Peach Bottom Atomic Power Station, Unit 3
Facility Operating License No. DPR-56
NRC Docket No. 50-278

SUBJECT: License Amendment Request: AR A1418692
Safety Limit Minimum Critical Power Ratio (SLMCPR) Change

LICENSE AMENDMENT REQUEST: AR A1418692

MARKED UP TECHNICAL SPECIFICATION

Figure 1 Reference Core Loading Pattern – Cycle 14

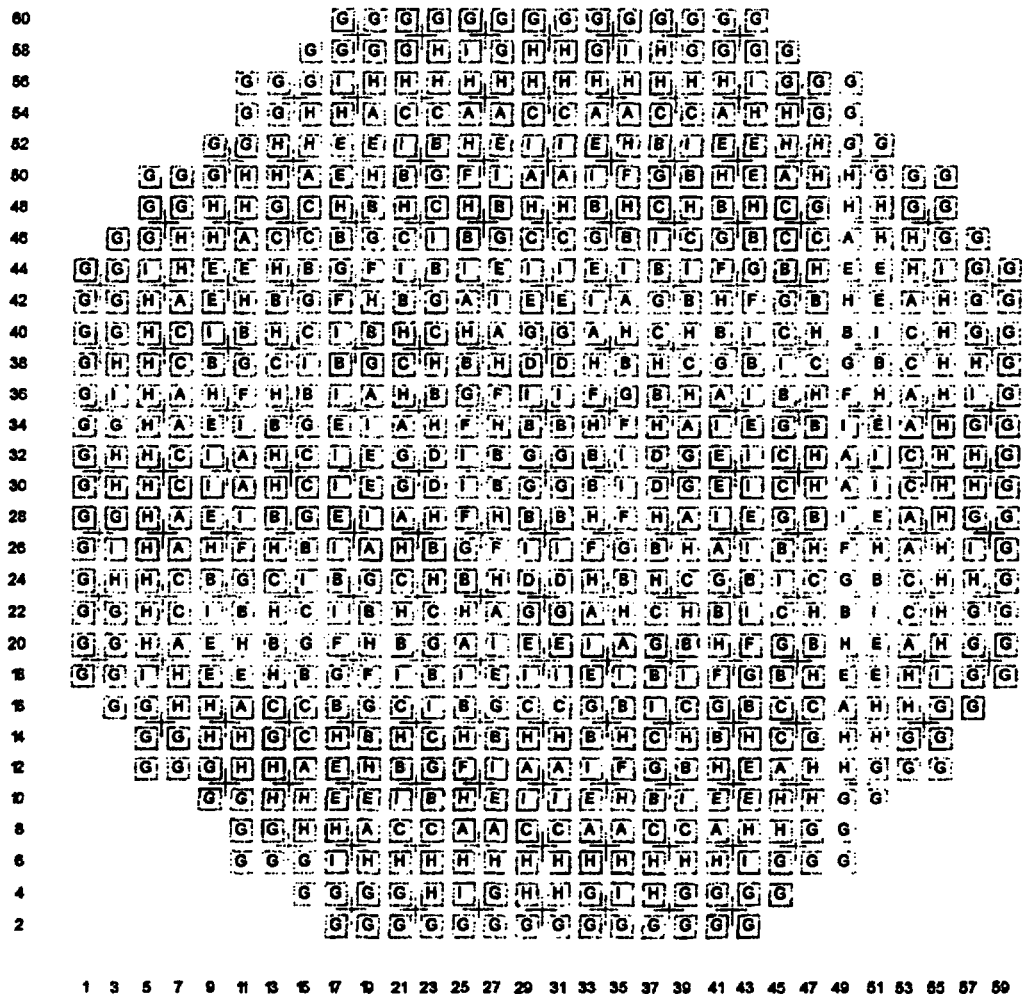
The core loading information for Peach Bottom 3 Cycles 14 and 15 is provided in Figures 1 and 2, respectively. The impact of the fuel loading pattern differences on the calculated SLMCPR is correlated to the values of [[]]
